PA-305062

Product Advisory

Deprecation of Legacy Feature

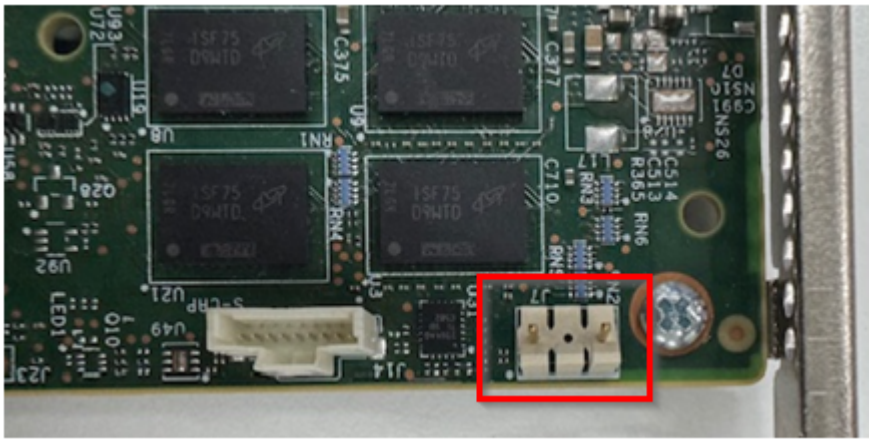
Aero generation MegaRAID controllers have the RAID upgrade key header still populated on the board. This key is a legacy feature that enables customers to field update the RAID features by applying a RAID upgrade key. This upgrade mechanism is no longer required since all firmware features are enabled by default. The header will be removed. The following picture shows the header (red box).

This update will be a rolling change and not indicated by a revision change. After April 1, 2026, this header will not be included on new manufactured boards. Actual shipment dates will depend on inventory and orders.
